SUBJECT: OPERABILITY DETERMINATION FOR THE CALLAWAY PLANT  
TECHNICAL SPECIFICATIONS REQUIREMENTS WHEN ONE MAIN  
STEAM ISOLATION VALVE ACTUATOR TRAIN IS REMOVED FROM  
SERVICE

## OPERABILITY DETERMINATION FOR CALLAWAY MAIN STEAM ISOLATION VALVE (MSIV)

### Operability Evaluation of Callaway MSIV Actuators

**Figure 4**  
**MSL Break**  
**Single Failure of SI Inst Train**  
**With Train B Actuator Removed From Service**  
**MSIV Fails to Close**

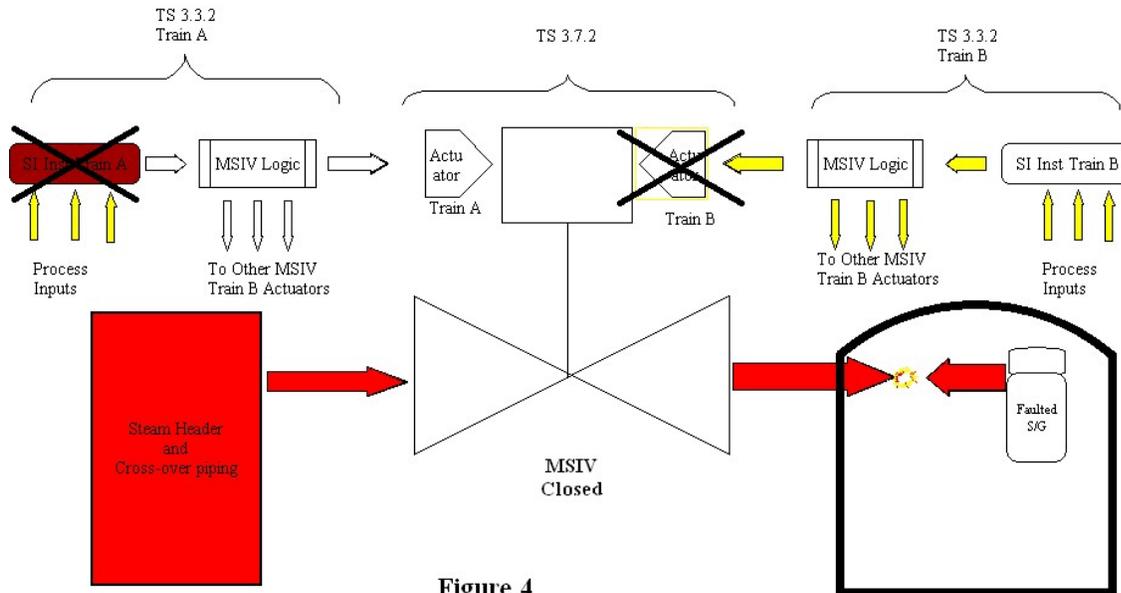
Figure 4 illustrates the system response with the Train B actuator removed from service with the single failure of the Train A SI Instrument Logic. The MSIV, with the actuator removed from service, fails to close.

**Figure 6**  
**MSIV MSL Case**  
**With One Inop Actuator Train**  
**Removed From Each MSIV**  
**Uncontrolled Blowdown of All S/G**

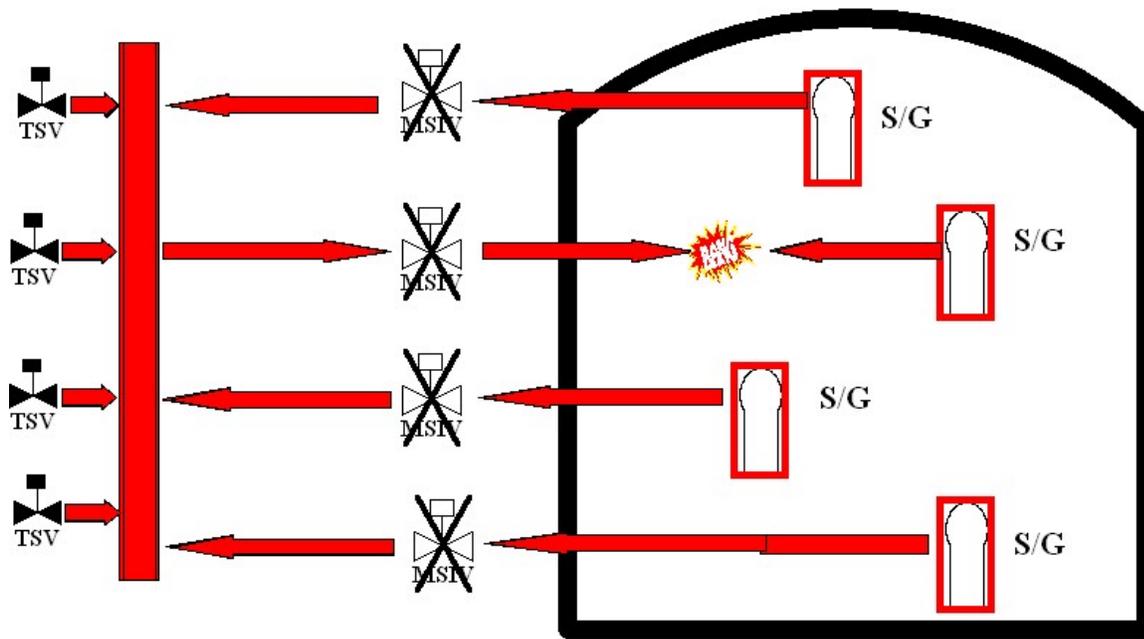
RIS Section 2.1.b states that SSCs that are not explicitly required to be operable by TS, but perform required support functions (as specified by the TS definition of operability), are also required to be operable by TS. The actuators, a sub component of the MSIV, fall into this category. The MSIV safety function, with the assumed single failure of an SI instrument train, cannot be accomplished without both MSIV actuators available. The MSIV TS out of service time must be applied if an actuator is not capable of performing the intended function.

pressure much greater than the design value of 60 psig, directly challenging the fission product barrier. The uncontrolled blowdown of all steam generators qualifies as a severe accident. The resulting rapid reactor coolant system cool down and depressurization would also indirectly challenge the fuel clad by a return to power (local peaking) and the depart from nucleate boiling. 10 CFR 50.36(c) (ii) (C), Criterion 3, requires TS for SSC that are part of the primary success path and which function or actuate to mitigate a DBA or transient that either assumes the failure of or presents a challenge to the integrity of a fission product barrier. The MSIVs fall into this category. Both actuators on each MSIV are also required to be functional for the MSIV to perform the safety functions described in the accident analysis. Both actuators must be functional for the MSIV to be operable under TS 3.7.2.
